HISTORIC AND DESIGN REVIEW COMMISSION

HDRC CASE NO: 2017-400
ADDRESS: 319 W MITCHELL ST
LEGAL DESCRIPTION: NCB 2852 BLK LOT 21 & 22 (LADD LITTLE SUBD UT-4)
ZONING: IDZ CD RIO-4
CITY COUNCIL DIST.: 5
APPLICANT: Mariela Valdivia
OWNER: Little Lad Investments, LTD
TYPE OF WORK: Final approval of a four story, multi-family structure
APPLICATION RECEIVED: February 16, 2018
60-DAY REVIEW: April 17, 2018
REQUEST:

The applicant is requesting a Certificate of Appropriateness to construct a four story, multi-family structure to feature 81 units.

MV: OVERVIEW OF MATERIALS.

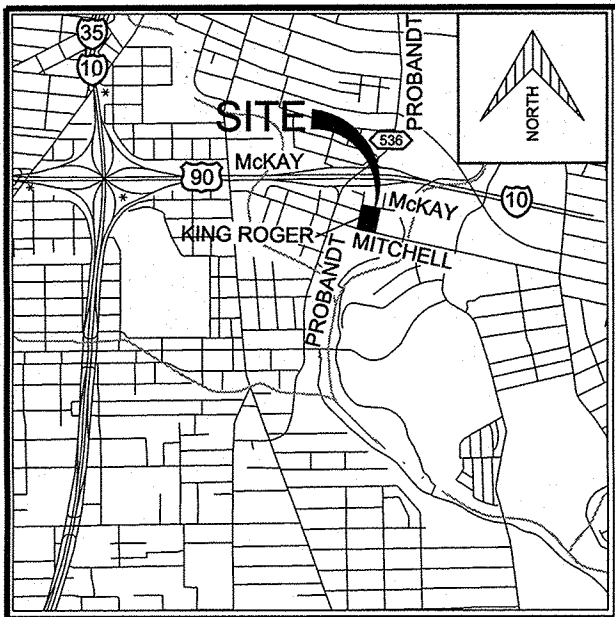
JG: PROVIDE ADDITIONAL RENDERINGS NOTING ROOF PROFILES.

LF: OKAY WITH GABLES - THEY PROVIDE SEPARATION
